PLANT NAME: Oconee 2 & 3

Proposed amdt to OL/change to tech specs:
consisting of revisions to tech specs with
regard to safety limits for reactor thermal
power and power imbalance combination and
to flux-flow and power-imbalance trip set-
points...(40 cys encl rec'd)

Re: Oconee Nuclear Station
Docket Nos. 50-270, -287

This letter constitutes Duke Power Company's application for revision of the Oconee Nuclear Station Technical Specifications, pursuant to 10CFR50, §50.90. The proposed revision pertains to Oconee Units 2 and 3 and modifies (i) the safety limits for the reactor thermal power and power imbalance combination and (ii) the Reactor Protection System (RPS) flux-flow and power-imbalance trip setpoints.

Figure 2.1-2C

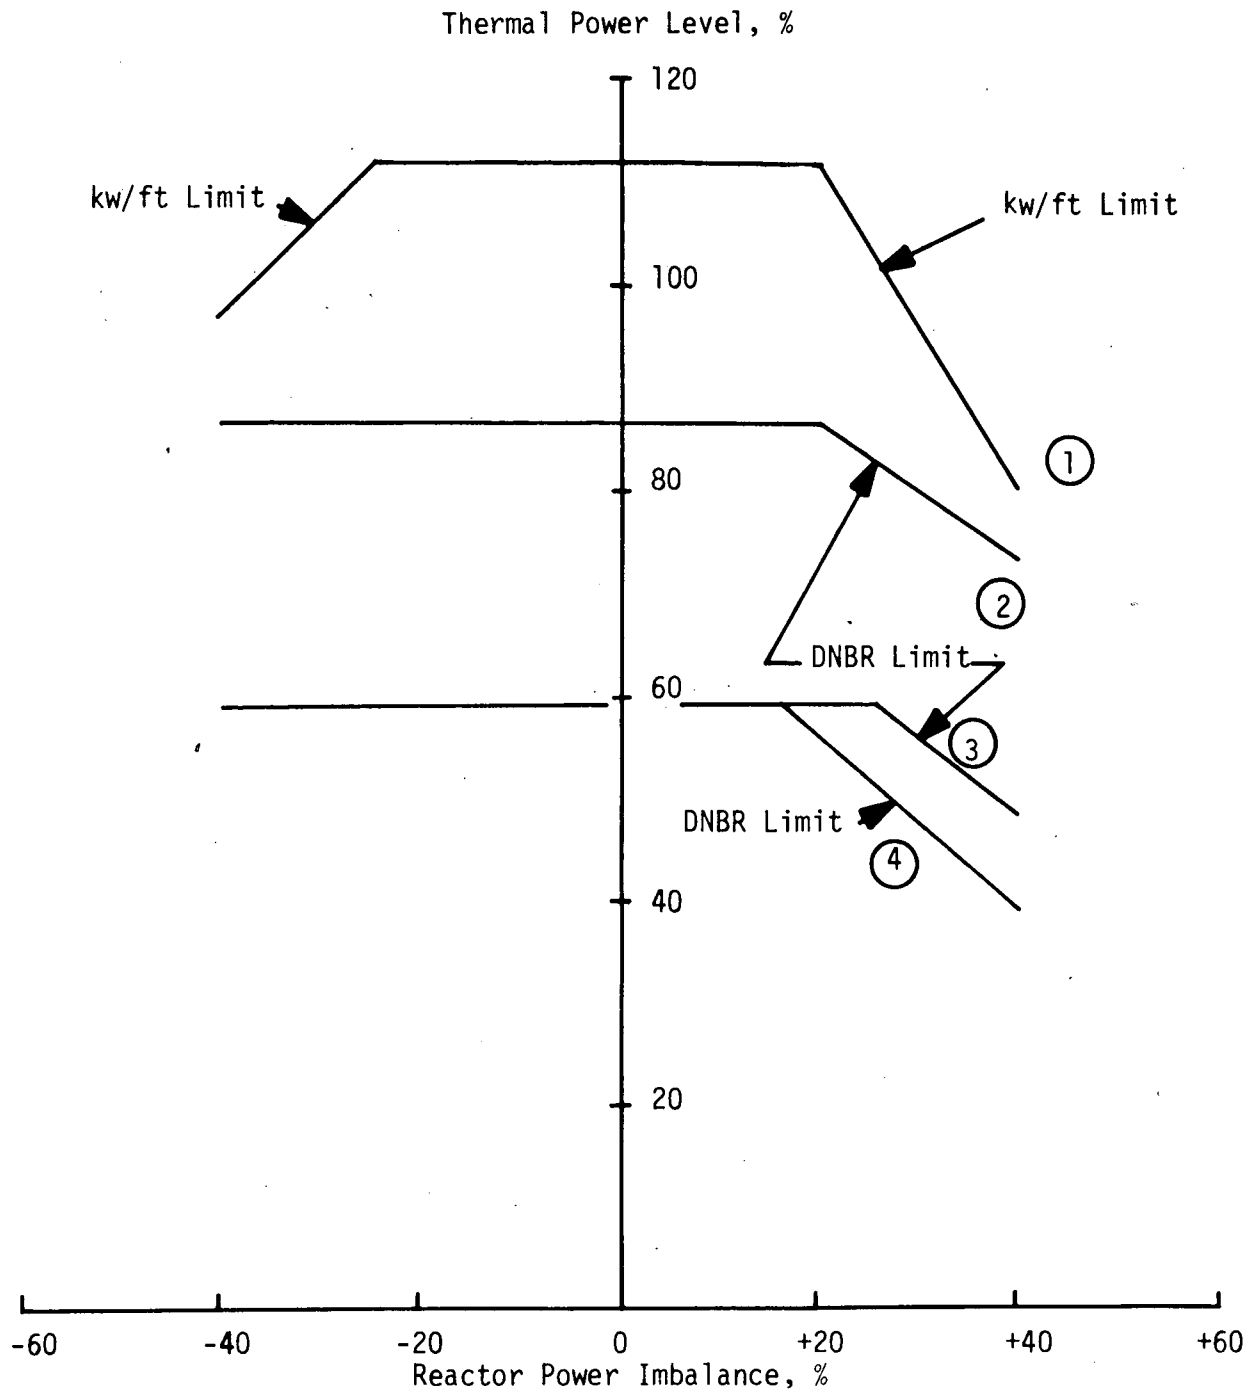
The proposed revision in imbalance limits necessitates a reduction of the flux/flow ratio from 1.07 to 0.961 for single loop operation in order to provide adequate margin from the revised imbalance safety limits.

plus the maximum calibration and instrument error. The maximum thermal power for other coolant pump conditions are produced in a similar manner. A flux-flow ratio of 0.961 is used for single loop conditions.

Figure 2.3-2B

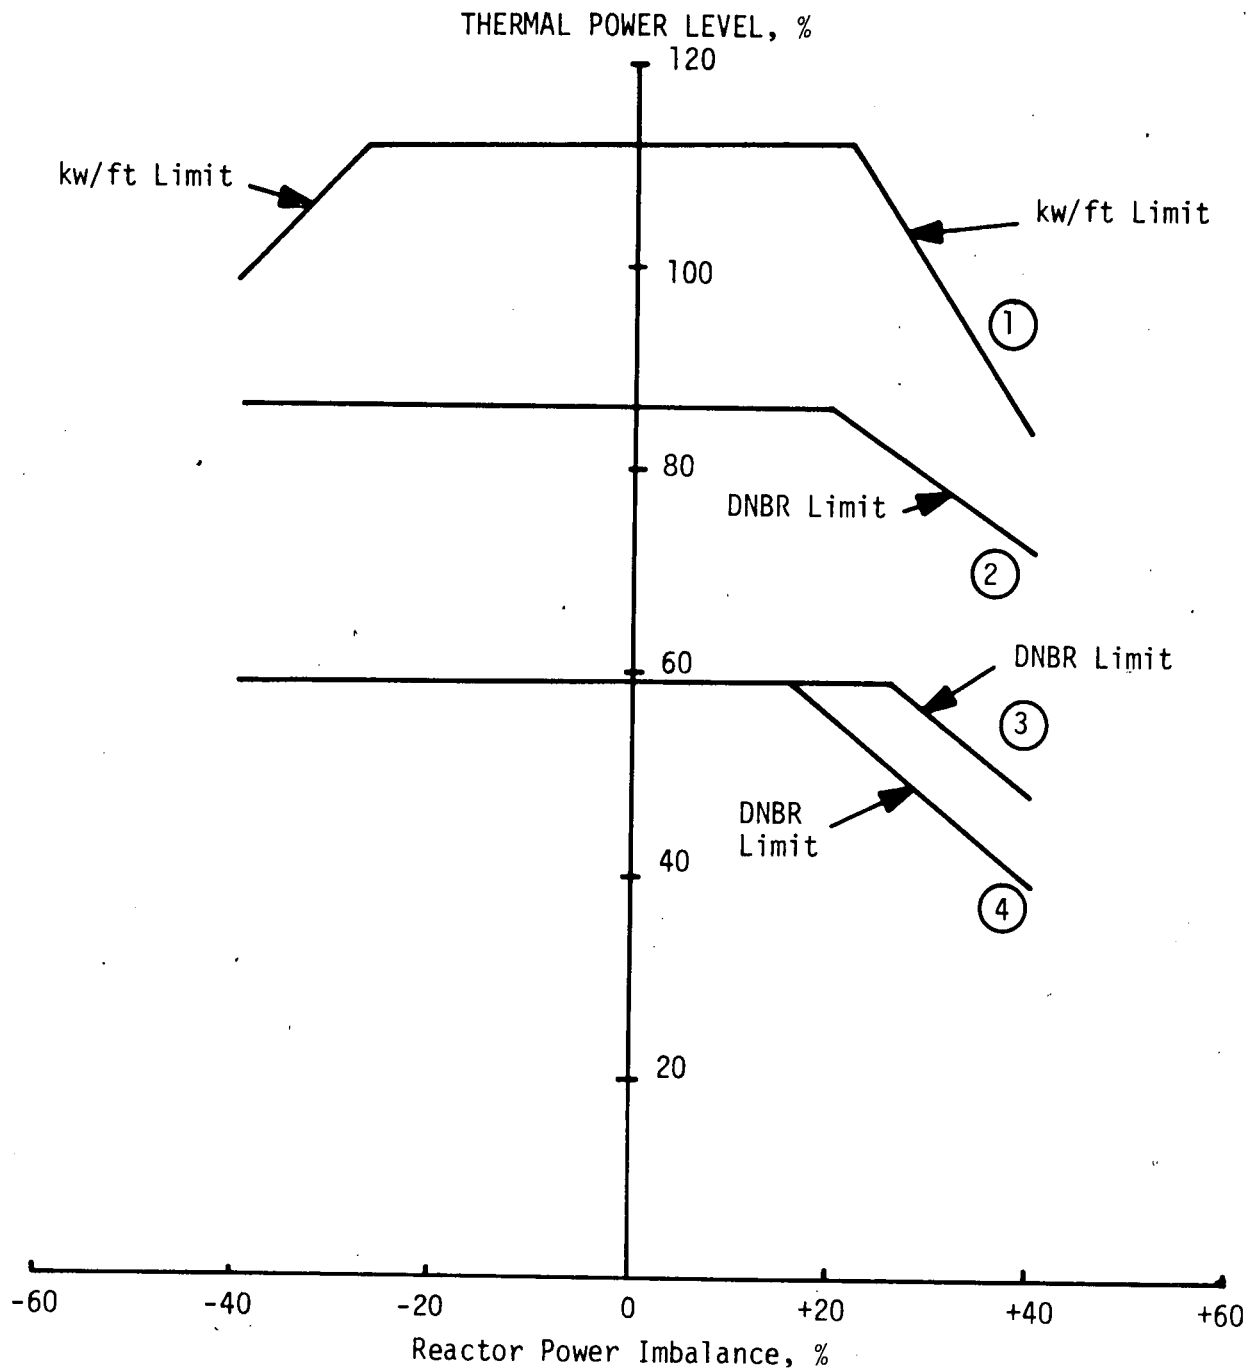
level trip and associated reactor power/reactor power-imbalance boundaries by
 1.08% - Unit 1 for a 1% flow reduction.
 1.07% - Unit 2
 1.07% - Unit 3
 For Units 2 and 3, the power-to-flow reduction factor is 0.961 during single
 loop operation.

1. Reset the pump contact monitor power level trip setpoint to 55.0%.
2. Trip one of the two protective channels receiving outlet temperature information from sensors in the Idle Loop.
3. (Unit 1) Reset the protective system maximum allowable setpoints as shown in Figure 2.3-2A2. Tripping one of the two protective channels receiving outlet temperature information from the idle loop assures a protective system trip logic of one out of two.
4. (Units 2 and 3) Reset flux-flow setpoint to 0.961.

*For two pumps in one loop, the flux-flow setpoint must be 0.961.
